**Amendment No. 1**

**ERCOT Standard Generation  
Interconnection Agreement**

**Core Solar SPV V LLC**

**FIRST AMENDMENT TO  
ERCOT STANDARD GENERATION INTERCONNECTION AGREEMENT**

# **Exhibit "C2"** **One Line Diagram – TSP Interconnection Facilities, Generation Interconnection Facilities and The Plant**

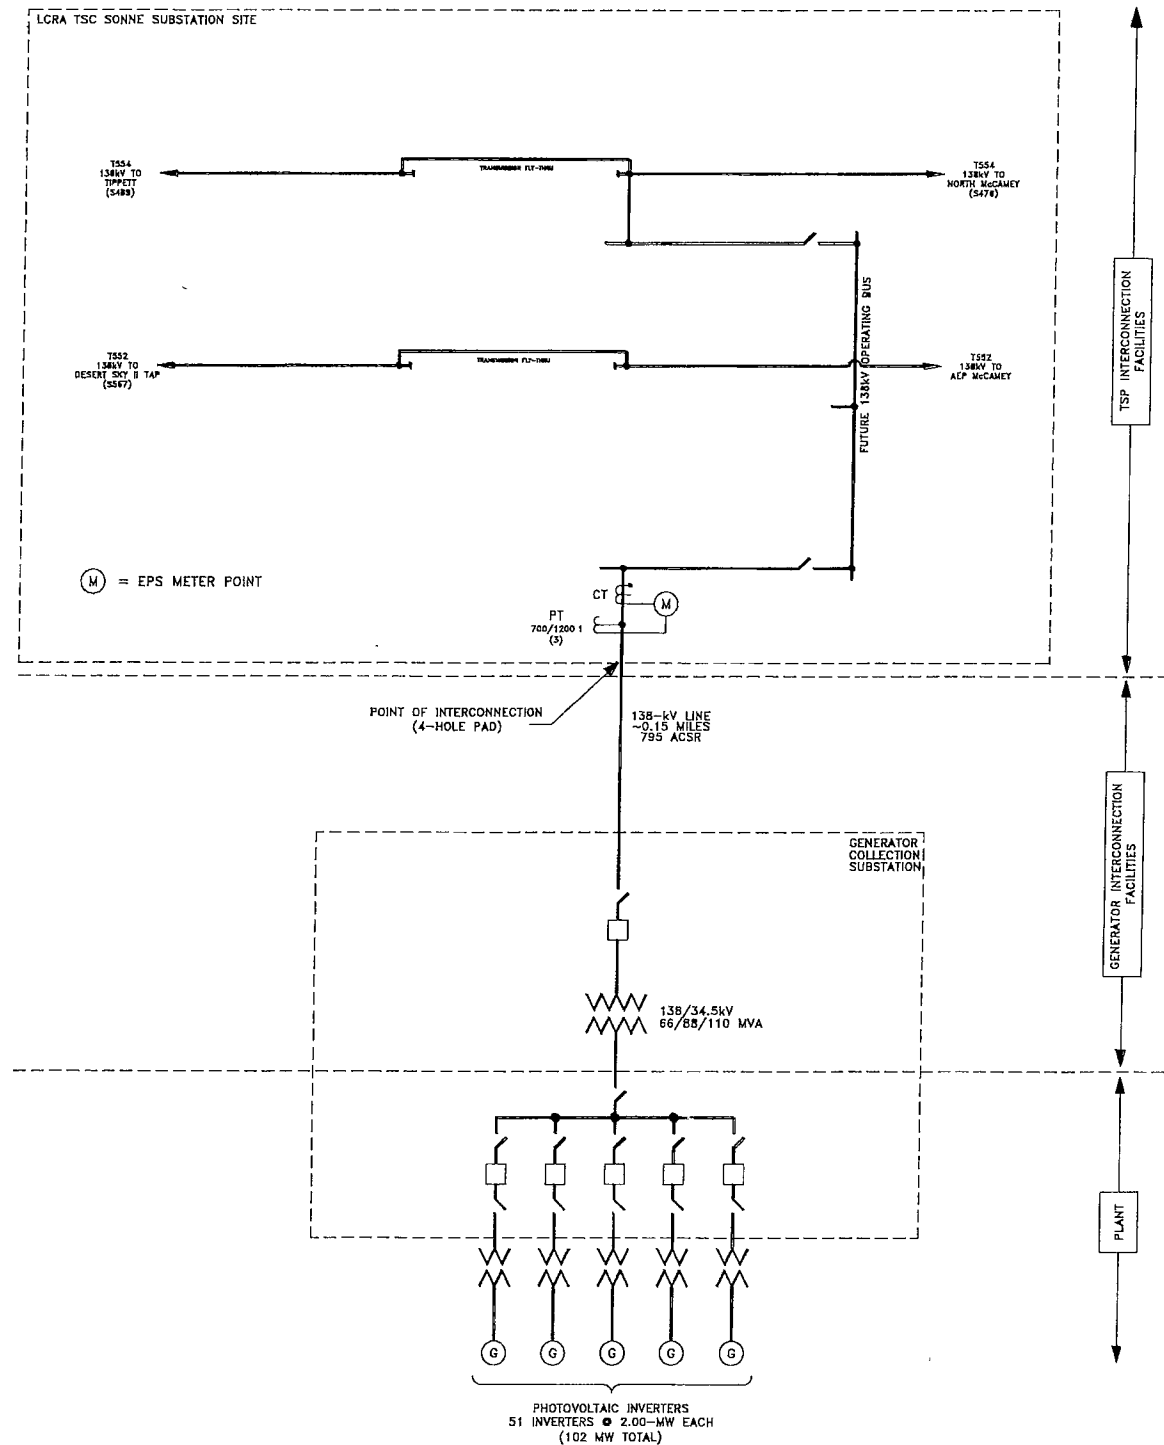
**WHEREAS**, the TSP desires to revise the proposed TIF by relocating certain EPS metering facilities from the Generator's proposed step-up substation to the proposed TSP Substation.

1. Exhibits "B", "C", "C1", "C2", "C3", "D" and "E" are deleted in their entirety and the Exhibits "B", "C", "C1", "C2", "C3", "D" and "E" attached to this First Amendment are hereby added to the Agreement in lieu thereof.

5. Type of Generating Unit: 51 photovoltaic inverters rated at 2.00-MW each.
6. Metering and Telemetry Equipment:
  - A). TSP’s ERCOT polled settlement (“EPS”) metering shall be located at the TSP Substation. 138-kV extended range, metering current transformers will be used to accurately read the generation energy and power delivered to the grid and the auxiliary energy and power consumed through the Point of Interconnection. 138-kV metering accuracy voltage transformers shall also be installed by the TSP for the EPS metering. An EPS metering panel containing primary and backup EPS meters shall be furnished by the TSP and will be located in the TSP Substation.

- E). Three (3) 138-kV, 2000A three-pole line disconnect switches with tubular stands and foundations;
- F). Three (3) 138-kV Metering Accuracy Voltage Transformers;
- G). Three (3) 138-kV Extended Range Current Transformers;
- H). One (1) EPS metering panel;
- I). Two (2) EPS meters (one primary meter and one backup meter); and
- J). Communication panel(s)
